CITY OF ST. HELENS PLANNING DEPARTMENT
STAFF REPORT
Appeal, AP.1.23

ZONING: General Residential (R5)
LOCATION: Lot 10 of Hanna Place Subdivision; 4N1W-4AC-6503
PROPOSAL: Appeal of Sensitive Lands Permit (SL.2.23) for the construction of a retaining wall of up to 12' in height

File Number: Sensitive Lands Permit, **SL.2.23**

"ULTRA BLOCK"
SEGMENTAL RETAINING WALLS
271 and 275 North 15th Street
St. Helens, Oregon

OVERALL SITE PLAN

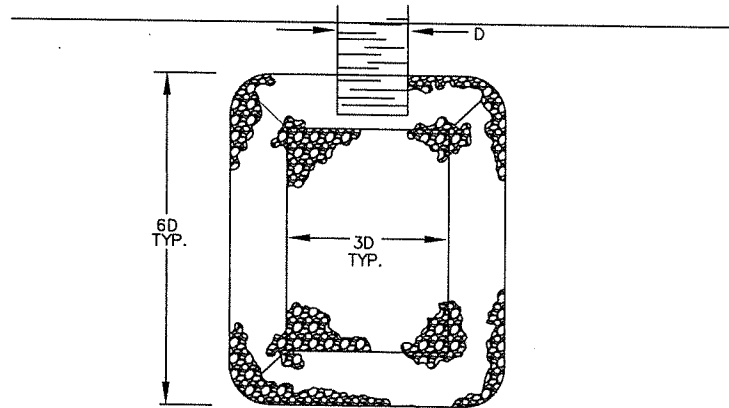
In the R5 zoning district, structures are required to have 10’ rear yards and 5’ side yards. It is recommended that a condition be added to require revisions to the plans that meet yard requirements. Alternatively, the applicant can receive a variance to the rear and side yard requirements.

1. Condition 2.a shall be revised to also include relocation of the retaining wall so that it meets the required yard (setback) requirements for the R5 zoning district unless variance(s) is/are granted to allow less.
2. << Anything else from the Commission to be added? >>

(b) There are two potential off-site impacts related to this proposal: erosion of fill onto adjacent properties and stormwater runoff. For erosion control, a condition requiring additional wall profile and edge conditions to detail how the wall will tie into the existing rock bluff to ensure all rock/fill will be contained on Lot 10 is needed. For stormwater runoff, the wall location must be revised to show that the stormwater outfall and related infrastructure are located entirely on Lot 10. This will require shifting the wall back from the property line to

accommodate the required outlet rip rap protection shown in the attached details. In addition, the location of where the outfall daylight cannot be designed to encourage runoff onto existing pavement below (located along the northwest side of the lot). The final outfall drainage plan to be reviewed and approved by City Engineering.

UltraWall

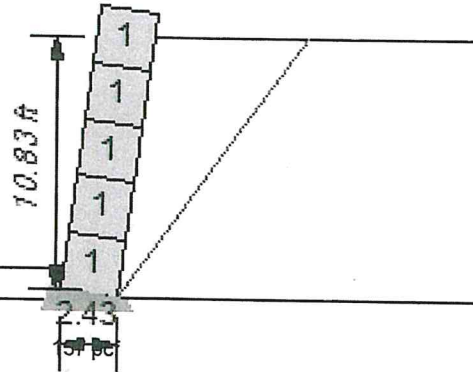
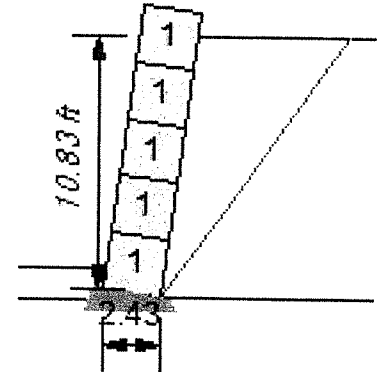
- No wetland setbacks are shown to demonstrate that the subject development complies with state and federal law, and the 2021 St. Helens Stormwater Plan, sections 5 and 6.
- The “UltraWall” shown in the submission is for a different project (271-275 N. 11th), unrelated to the 15th Street Site Development Plan. The proposed wall for this project application should be shown. There is no evidence of any tilted walls in the vicinity of this project.
